GRS
Gesellschaft fuer Reaktorsicherheit
(GRS) mbH
(Society for Reactor Safety)

INVESTIGATIONS ON THE COMPARISON OF
GREATEST POSSIBLE ACCIDENT CONSEQUENCES
IN A REPROCESSING PLANT AND IN A NUCLEAR
POWER PLANT
(CRITICAL COMMENTS ON WORK REPORT AB-290)

GRS - A - 59 (NOVEMBER 1977)

Figure VI 13-7. Mortality probability for an affected population versus distance from reactor for two hypothetical weathers: stability category A, wind speed = 0.5 m/sec; stability category F, wind speed = 2.0 m/sec.

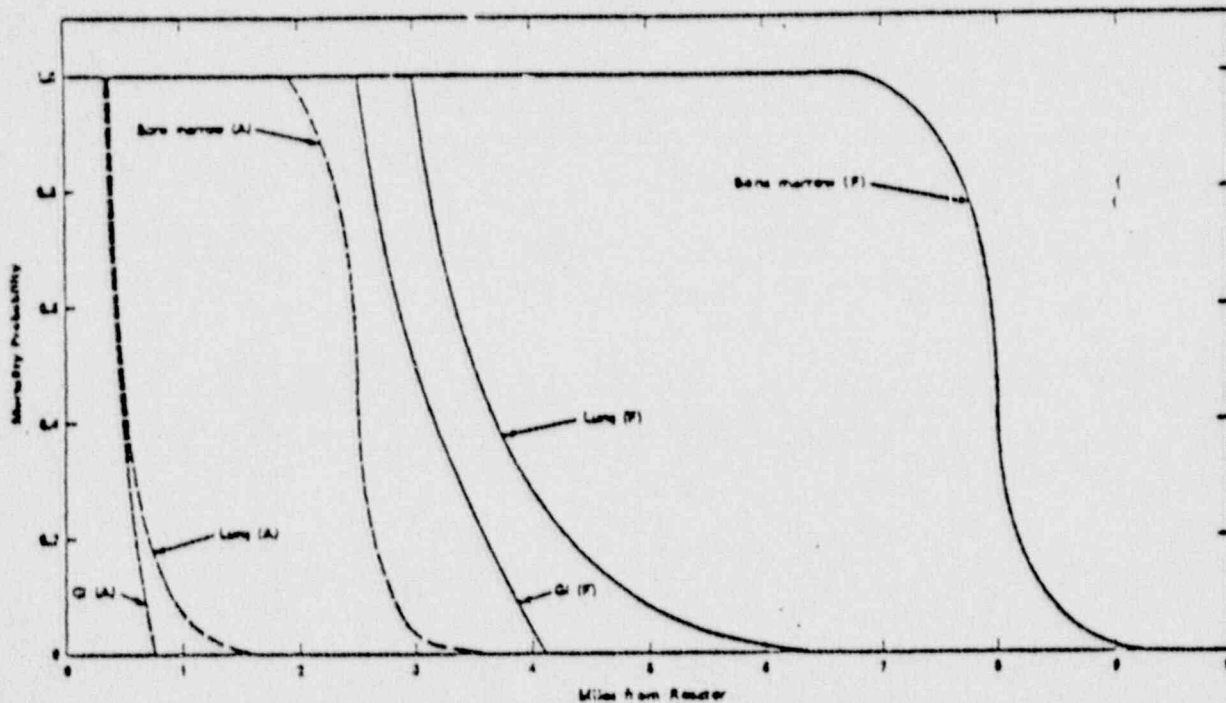
The American risk study reveals that, in the most unfavorable case (weather conditions F, release near ground), radiological effects which can lead in a short time to the death of the affected persons are not to be excluded up to distances between 7 and 9 miles (12 to 15 km). In the case of the most favorable conditions (weather class A), the limiting radius is about 3.5 miles (5 km).

Figure 7/15. Bone marrow dose D and probability T for acute radiation death with a 24-hour dwell.

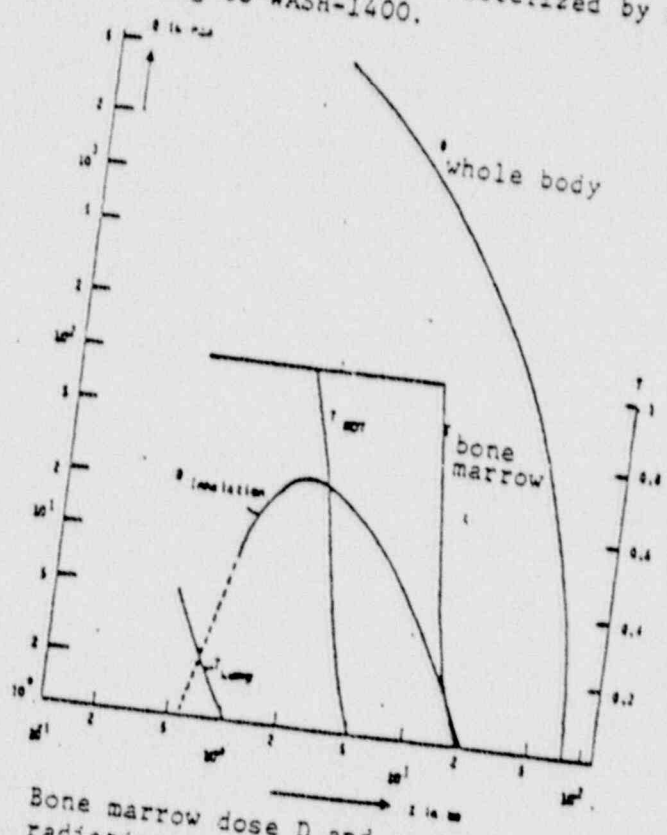
The result is published in Figure 7/15 of the above annual report. From this, there results a limiting radius for mortality of 12 to 20 km in the case of average weather conditions (category D) with rain.

The results are depicted in the following figure:

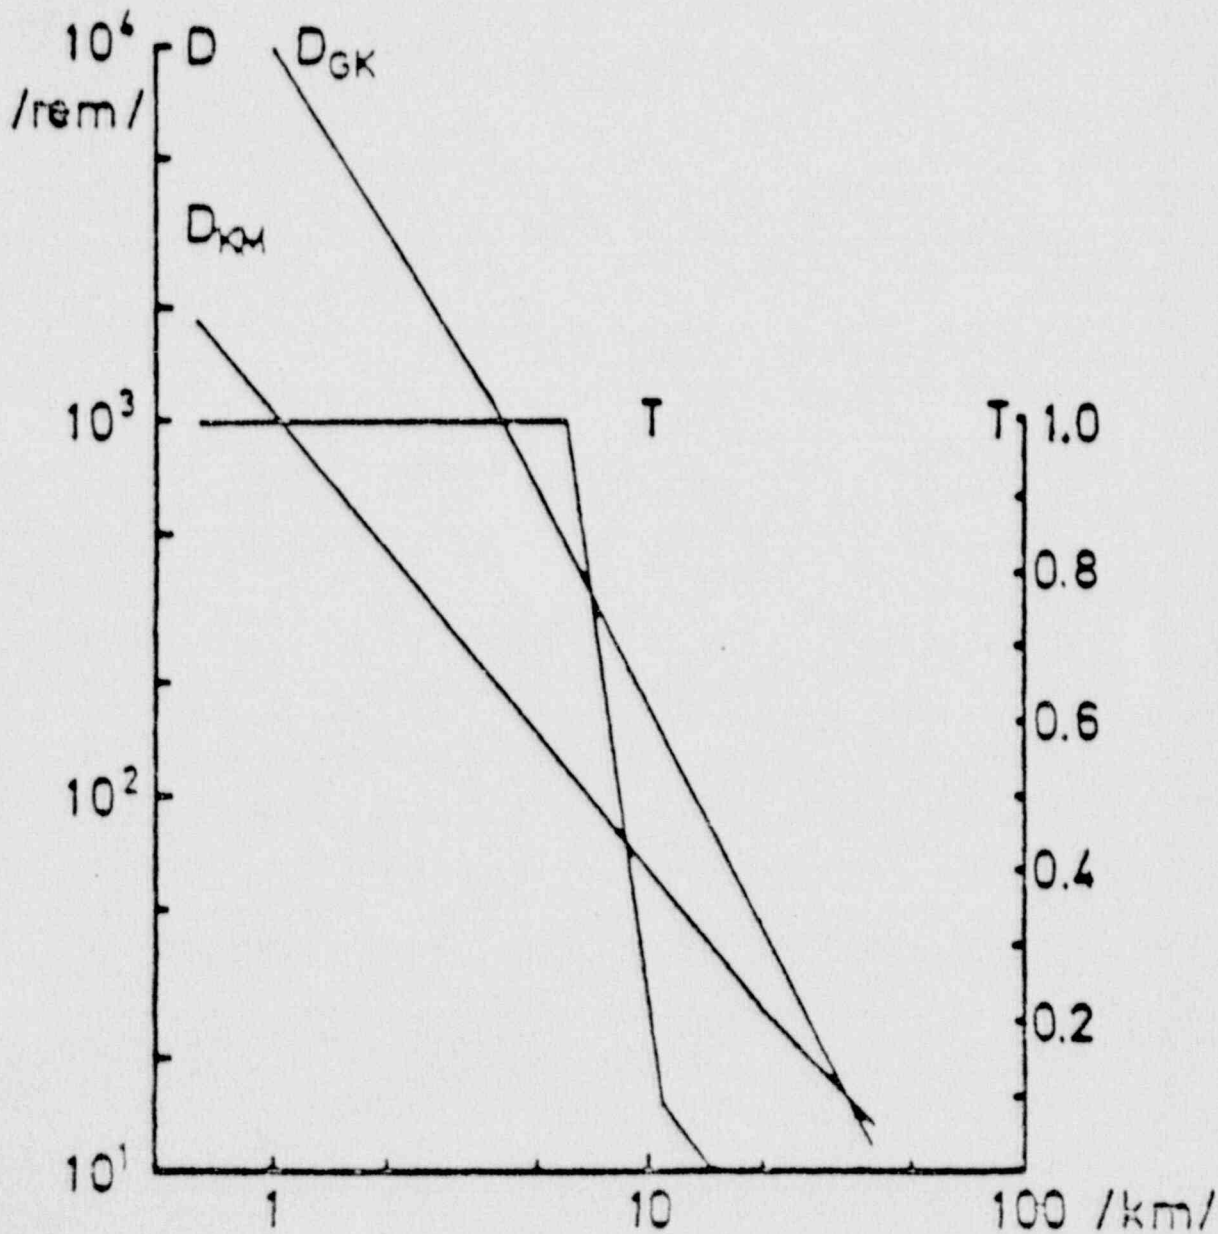
The limiting radius for early mortality accordingly lies in the area between ca. 8 and 15 km. Herewith, none of the effects reducing the consequences are considered such as, for example:
